Title - Sujet Wells PWC-2 and TWC-1 Upgrades	
Solicitation No. - N° de l'invitation F1700-176142/A	Amendment No. - N° modif. 003
Client Reference No. - N° de référence du client F1700-176142	Date 2018-05-24
GETS Reference No. - N° de référence de SEAG PW-\$PWY-025-8345	
File No. - N° de dossier PWY-7-40395 (025)	CCC No./N° CCC - FMS No./N° VME
Solicitation Closes - L'invitation prend fin at - à 02:00 PM on - le 2018-05-30	
F.O.B. - F.A.B. Plant-Usine: <input type="checkbox"/> Destination: <input checked="" type="checkbox"/> Other-Autre: <input type="checkbox"/>	
Address Enquiries to: - Adresser toutes questions à: Fung, Donna(PWY)	Buyer Id - Id de l'acheteur pwy025
Telephone No. - N° de téléphone (604) 671-9689 ()	FAX No. - N° de FAX (604) 775-6633
Destination - of Goods, Services, and Construction: Destination - des biens, services et construction: DFO - Chehalis River Hatchery - Agassiz, BC

Wells PWC-2 and TWC-1 Upgrades
Chehalis River Hatchery, Agassiz, BC

Chehalis River Hatchery – Tender Questions – Addendum 2

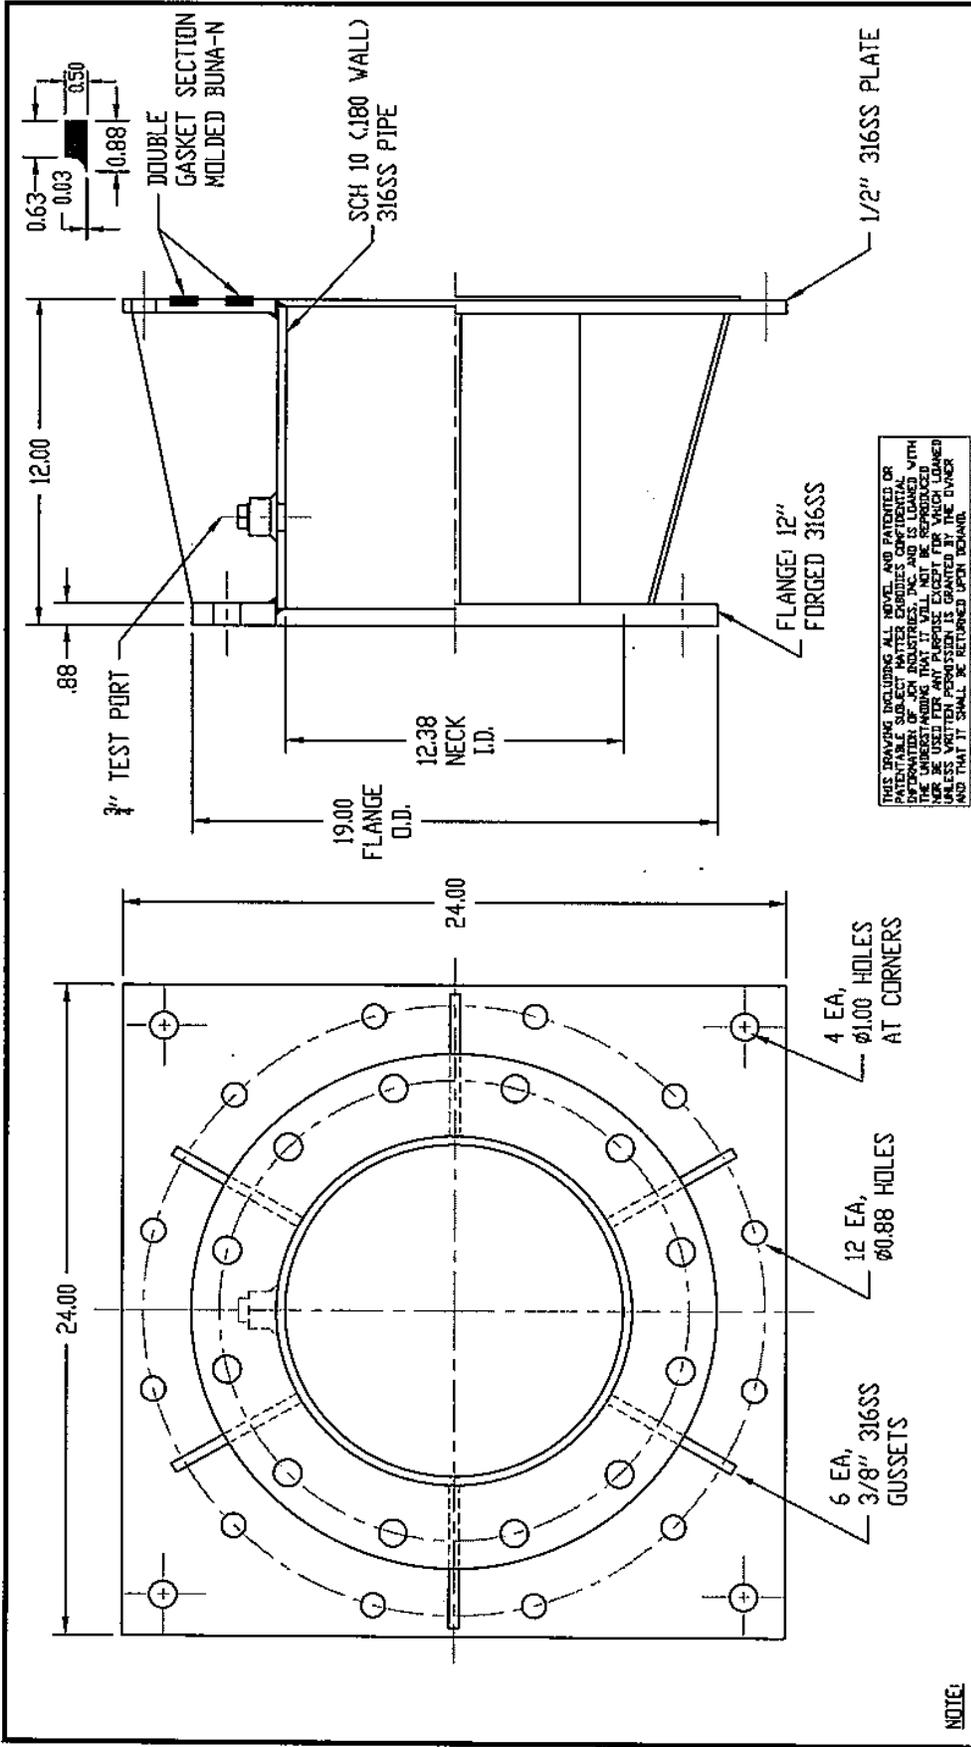
- All pipe work to be PVC C900 pipe. Please disregard the references to DR17 HDPE pipe. Please refer to Question 6 as well.
8. Drawing 11-29-343 shows a butterfly valve as part of the hot tap connection to the Aeration chamber, a Hot Tap cannot be performed through a butterfly valve, can we substitute the butterfly valve with a Resilient Seat gate valve as shown in other details of the drawings?

- Yes, the butterfly valve should be changed to a "Ductile Iron Epoxy Coated Resilient Seat Gate Valve Flange x Flange."
 - The Connection to the reservoir is to be made with a "JCM 6410-000 x 12 Wall Sleeve" (see attached Shop Drawing) supplied by Pacific Flow Control or approved equivalent
